Office Action Summary

10/796,144

This is the first Office Action for the serial number 10/796,144, RESERVOIR THAT A BRACKET IS INTEGRATED WITH, filed on 3/10/04.

Fig. 5

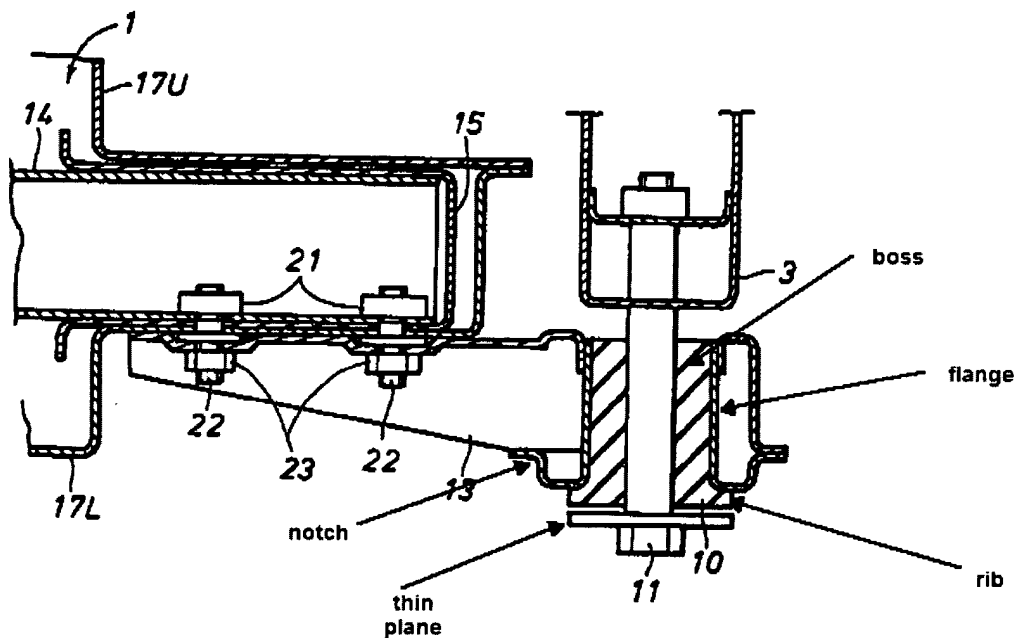
Kami teaches a reservoir comprising a tank (1), a bracket (13) integrated with the tank and an attaching portion/absorbing means (figure 5, 10-11) arranged with bracket. The attaching portion comprises a boss (10) for fixing to the vehicle (3) and flange portion arranged around the boss portion and connected to the tank. The reservoir further includes connection portion comprising notch (see drawing below). The reservoir includes first and second brackets (figure 2) having first and second attaching portions (figure 5, 10-11).

In regard to claims 3,5, and 13-14 Kami teaches the attaching portion comprising a rib portion and the first connecting portion comprising notch but fails to teach plural of rib portions connecting the boss. It would have been obvious for one of ordinary skill in the art at the time the invention was made to have added additional rib portion to the boss (transverse from existing rib) to prevent the boss from sliding down in vertical axis.

In regard to claims 4 and 6, Kami teaches the attaching portion includes a thin plane portion (adjacent to element 11) but fails to teach plural thin plane portions. It would have been obvious for one of ordinary skill in the art at the time the invention was made to have added additional thin plane portion to the attaching portion to provide additional support for retaining the boss within the flange of bracket.

Kami teaches plural of thin planes but fails to teach the thin planes are arranged between the rib portions. It would have been obvious for one of ordinary skill in the art at the time the invention was made to have modified the position and size of thin planes from top of rib to between the ribs to provide designer's preference for the location of the thin planes.
